# Work Order ID 112781

Item Name: Crosstube Turning Detail

<b>DART AEROSPACE LTD</b>		<b>Work Order:</b>	112781
<b>Description:</b> Crosstube Assembly (205/212 High Aft)		<b>Part Number:</b>	D212-664-241
<b>Inspection Dwg:</b> D212-664-241 Rev: D		<b>Page 1 of 2</b>

DRAWING NO. D212-664-241	TITLE CROSSTUBE ASSY (205/212 HI AFT)	REV. D	DART AEROSPACE LTD ENGINEERING ORDER		D.E.O. NO. D212-664-241-D-1	SHEET NO. SHEET 1 OF 2	SCALE NTS
DRAWN	CHECKED	MFG. APPR.	APPROVED	DE APPR.			
DATE 11.04.07	DATE 11.04.11	DATE 11.04.12	DATE 11/04/12	DATE 11.04.12

**D212-664-241/-241B  
ASSEMBLY DETAIL**

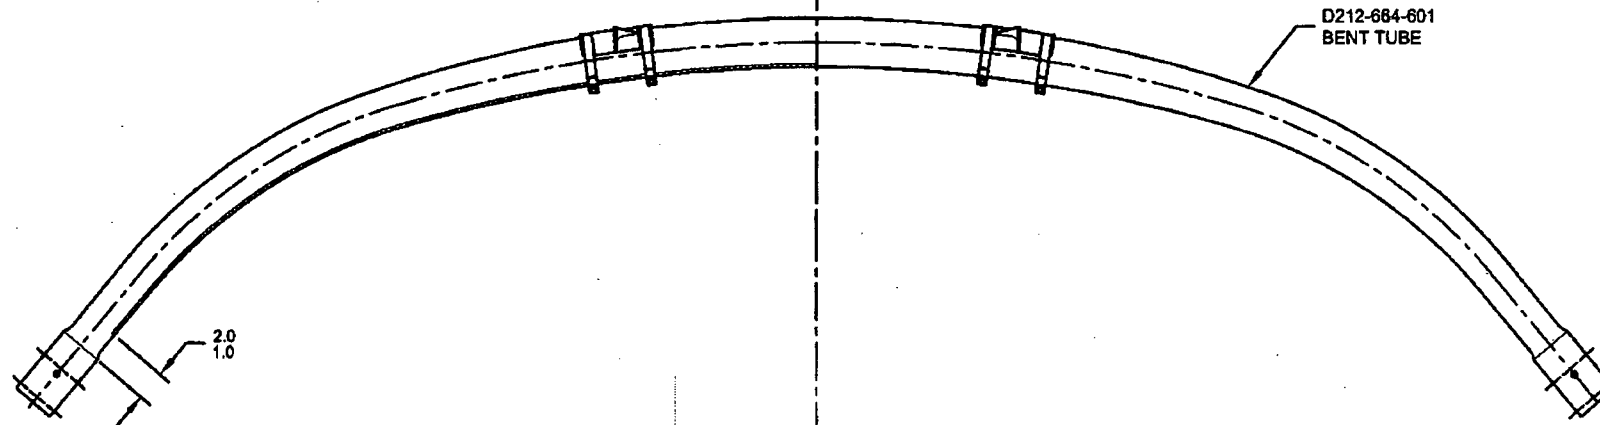
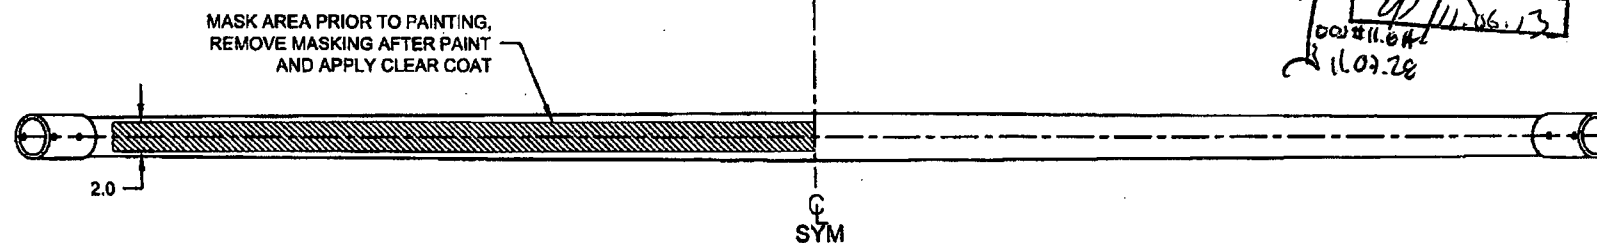
**PURPOSE:**

ADD AN INSPECTION WINDOW TO UNDERSIDE OF CROSSTUBE.

**CHANGE:**

NOTES 2 OF SHEET 1 IS AMENDED AS FOLLOWS:

**IS:**

- 2) FINISH: CHEMICAL CONVERSION COAT PER DART QSI 005 4.1  
PRIME INSIDE AND OUTSIDE PER DART QSI 005 4.2  
MASK UNDERSIDE OF CROSSTUBE AS SHOWN (HATCHED AREA) AND  
PAINT OUTSIDE PER DART QSI 005 4.2  
REMOVE MASKING AND APPLY CLEAR COAT

**WAS:**

- 2) FINISH: CHEMICAL CONVERSION COAT PER DART QSI 005 4.1  
PRIME INSIDE AND OUTSIDE PER DART QSI 005 4.2  
PAINT OUTSIDE PER DART QSI 005 4.2
